UNITED STATES PATENT AND TRADEMARK OFFICE

Office Action Summary

10/014,991

DETAILED ACTION

Fig. 3

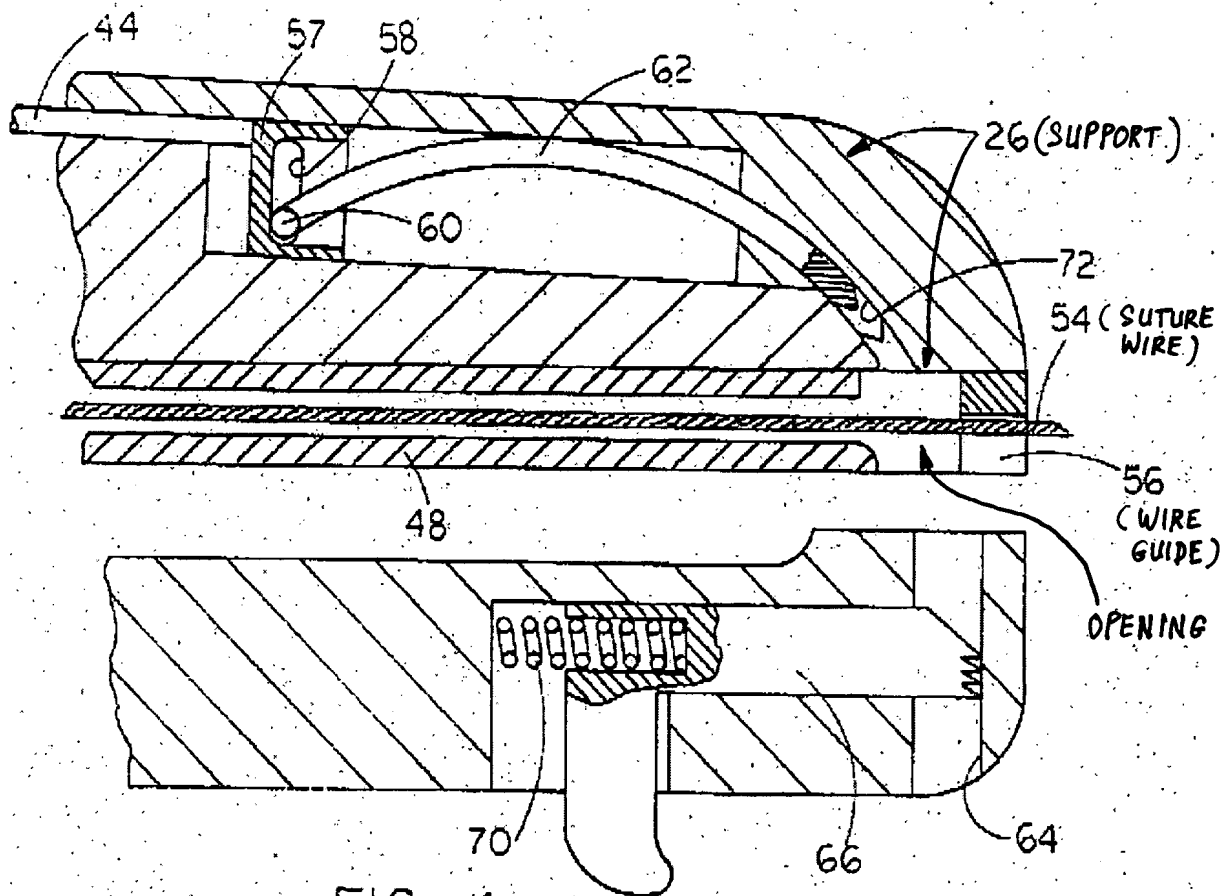
As to claims 68-70 and 72, Schweizer-'840 (F. 1-8) discloses suture cartridge 48 removably attached to suture instrument 10, suture wire 54, suture wire holder 52, a suture wire housing/cartridge 48 covering suture holder 52, elongated suture wire guide or groove 56 defining a guide path and a proximal opening proximal to the distal end of groove 56, suture wire guide support 26 and a drive mechanism including elements 44, 57 and needle 62 to draw the suture from the holder 52 and move the suture along guide path way defined by elongated suture wire guide 56 as recited in the claims.

As to claims 71 and 73, 75, Schweizer-'840 discloses substantially all limitations as recited in the claims, except for the elongated suture wire guide defining a tube. It would have been obvious to one having ordinary skill in the art at the time the invention was made to modify the Schweizer-'840 to have guide tube as recited in the claims, since changing the shape of the suture wire guide is only a choice of design, especially when the change does not critically improve the performance of the device.

As to claim 74, Schweizer-'840 discloses substantially all limitations as recited in the claims, except for a guide tube support including an approximately "I" shaped cross-section. It would have been obvious to one having ordinary skill in the art at the time the invention was made to modify the Schweizer-'840 to have guide tube support as recited in the claims, since changing the cross section of a portion of an element is only a choice of design, especially when the change does not critically improve the performance of the device.
